# Access Compliance Report

## Public Rights-of-Way

Intersection ID: 21987	Main Street: OLD_PROVIDENCE_RD	Cross Street: OLD_PROVIDENCE_LN	Location: SW
ADA ID: 0F5608F950AB	Ramp Type: Perp	Initial Pass/Fail: Fail	Overall Compliance: No
		Severity Score: 37.5

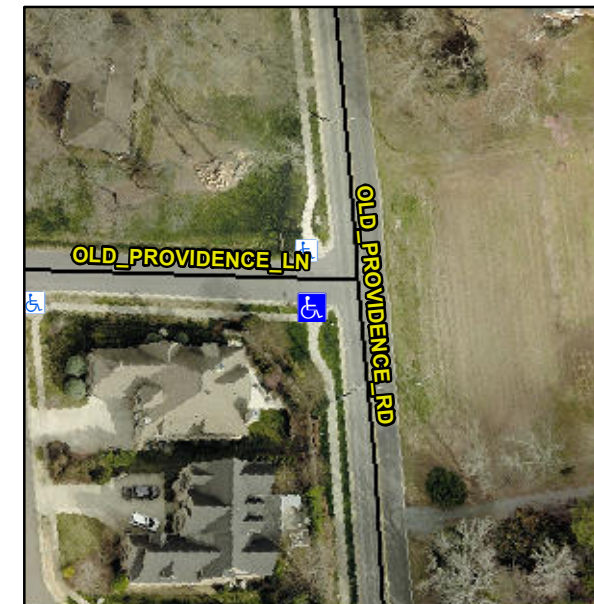
**Not Found, R304.5.3**

Compliance	Description	Data	Compliance	Description	Data
N/A	Ramp Length (in)	338.0	Yes	Ramp Slope (%)	9.1
Yes	Ramp Width (in)	48.5	No	Ramp XSlope (%)	8.6
N/A	Flare Type LT	N/A	N/A	Flare Type RT	N/A
N/A	Flare Slope LT (%)	N/A	N/A	Flare Slope RT (%)	N/A
N/A	Flare Traversable LT?	N/A	N/A	Flare Traversable RT?	N/A
N/A	Landing Length (in)	N/A	N/A	DWS Provided?	N/A
N/A	Landing Width (in)	N/A	N/A	DWS Contrast?	N/A
N/A	Landing Slope (%)	N/A	N/A	DWS Length (in)	N/A
N/A	Landing X Slope (%)	N/A	N/A	DWS Full Width?	N/A
N/A	Landing Curb? (Y/N)	N/A	N/A	DWS Offset (in)	N/A
N/A	Shared Landing?	N/A			
N/A	Gutter Ponding?	N/A	N/A	Gutter Slope (%)	N/A
N/A	Gutter Lip Ht (in)	N/A	N/A	Gutter X Slope (%)	N/A
N/A	Painted X Walk1?	No	N/A	Painted X Walk2?	N/A
	X Walk 1 Direction	To N		X Walk 2 Direction	N/A
N/A	X Walk 1 Width (in)	N/A	N/A	X Walk 2 Width (in)	N/A
	X Walk 1 Slope (%)	1.7		X Walk 2 Slope (%)	N/A
	X Walk 1 X Slope (%)	9.4		X Walk 2 X Slope (%)	N/A

**Remove & Replace Entire Ramp.**
